PZ&B Staff Combination Memorandum: Landmarks Preservation Commission and Town Council

SUBJECT: ZON-24-0009 (COA-24-0002) 195 VIA DEL MAR (COMBO)

MEETING: JUNE 21, 2024, LPC
JULY 10, 2024, TC

PROPOSED
 S. COUNTY ROAD ELEVATION
 3/4" = 1' - 0"

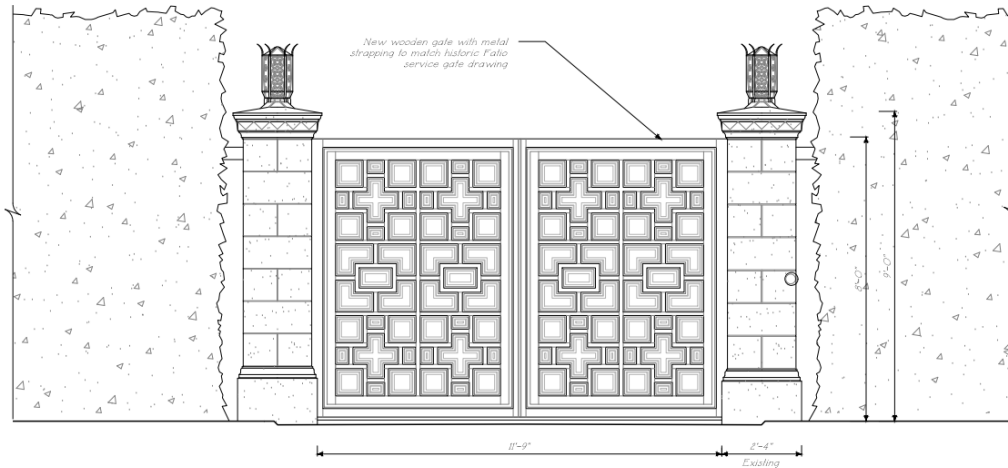
The rolling gate along the South County Road frontage will be replaced with a new pair of wooden gates that are inspired by the original Fatio design for the gates at this location. However, the existing location of the gate and piers does not provide the minimum of 18 feet to the street pavement as required per Section 134-1668. Therefore, a variance is required to reduce the required vehicular backup driveway space 11'-4".

Other properties north and south of 195 Via Del Mar have gates along South County Road. Although these gates typically have less opacity than the proposed design, they are appropriate for the landmarked property since they will replace an existing opaque gate and are inspired by Fatio's original design.

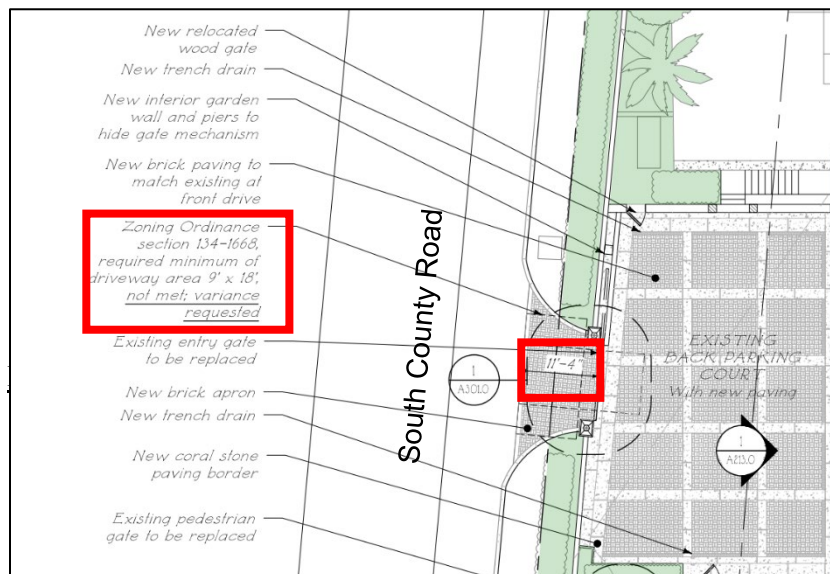
The variance request is summarized in the table and diagram below:

Code Section	Required	Proposed	Variance
Variance: Sec. 134-1668	18' Driveway Depth	11'-4" Existing Driveway Depth	6'-8"

Site diagram illustrating areas
of landscape modification

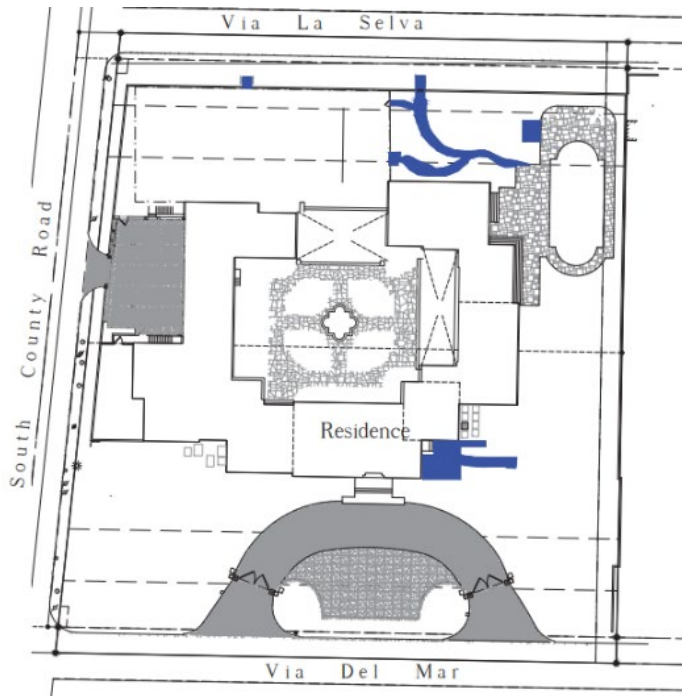
Minimal hardscape and landscape changes are proposed. A mechanical equipment unit will be relocated outside of the building setbacks. An existing *Calophyllum Brasiliense* (Brazilian Beauty Leaf) shrub will be removed on the southeast side of the property. In addition, a small portion of Brazilian Beauty Leaf hedging will also be removed along Via La Selva to accommodate a new pedestrian gate. Lastly, existing shrubs and ground cover will be relocated to create a new path leading to the new pedestrian gate.
